01-011/14 – 2007-2012 CX-7 - CLUNKING NOISE FROM NO. 3 ENGINE MOUNT

Subject: CLUNKING NOISE FROM NO. 3 ENGINE MOUNT	Bulletin No: 01-011/14
	Last Issued: 04/15/2014

2007-2012 CX-7

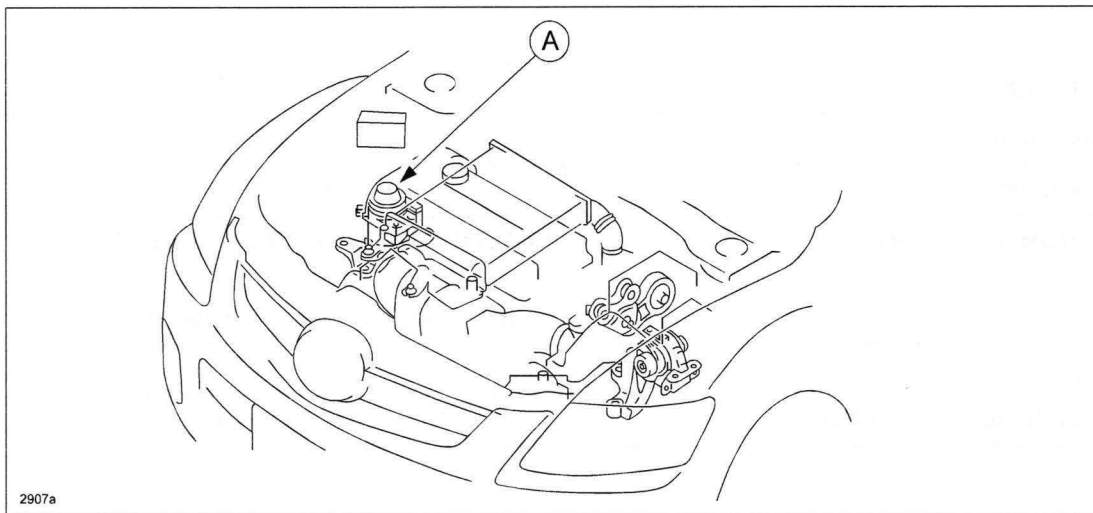
Some vehicles may exhibit a clunk noise from the engine compartment when driving over rough roads or over a speed bump. The noise may occur in areas of high ambient temperatures.

Due to high heat, the lubricant inside the No. 3 engine mount rubber (A) may become ineffective, causing a stick-slip noise between the casing and the rubber, however, there is no seepage from the engine mount.

The engine mount rubber uses a new type of lubricant to eliminate this concern.

1. Verify the customer concern.
2. Replace the No. 3 engine mount according to the instructions on MS3 online or the Workshop Manual: (CX-7 2.3L (L3 Turbo) Engine, section 01-10 NO. 3 ENGINE MOUNT DISASSEMBLY/ASSEMBLY) or (CX-7 2.5L (L5) Engine, section 01-10 NO. 3 ENGINE MOUNT DISASSEMBLY/ASSEMBLY).
3. Verify the repair.
